TECHNICAL INFORMATION

TYPE NO FB 5100 standard and maxi	TYPE Freshbrewer	T.I.-NO FB 05/2002				
SERIAL NUMBERS AFFECTED From machine No 516879 (standard) and machine No 514893 (maxi)	ISSUED BY Documentation/Wittenborg Odense					
SUBJECT Suspension plate for brewer	ISSUED FOR (X): <table border="1"> <tr> <td>Action</td> <td></td> </tr> <tr> <td>Information</td> <td>X</td> </tr> </table>		Action		Information	X
Action						
Information	X

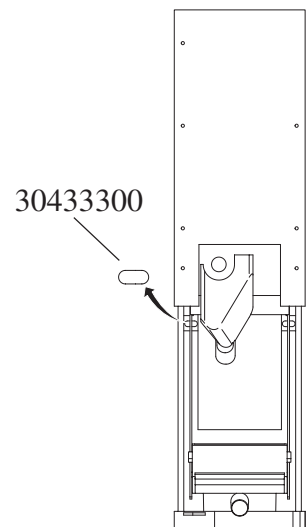
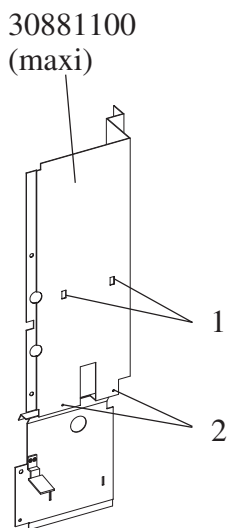
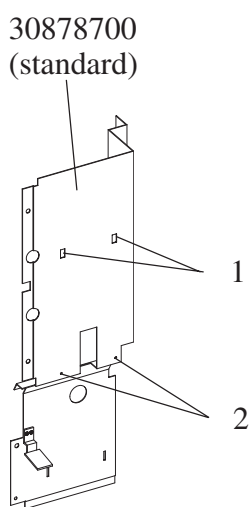
- Suspension plate for brewer **30878700 (standard)** - used in FB 5100 standard models and suspension plate for brewer **30881100 (maxi)** - used in FB 5100 maxi models have been changed. The two holes (see 1 on illustrations below 30878700 and 30881100) have been enlarged in order that the brewer unit can be adjusted horizontally. The two holes have also been moved 2 mm downwards as well as the two holes (see 2 on illustrations below 30878700 and 30881100).
 Transport fittings for brewer **30433300** - used in both FB 5100 standard and maxi models have been changed. The two holes are now oblong holes instead of round holes (see illustration below 30433300).

- If the brewer unit is not positioned correctly, it is now possible to adjust it horizontally in order that it does not interfere with the door. The holes have been moved downwards to ensure that the brewer unit does not scratch the top of the door.
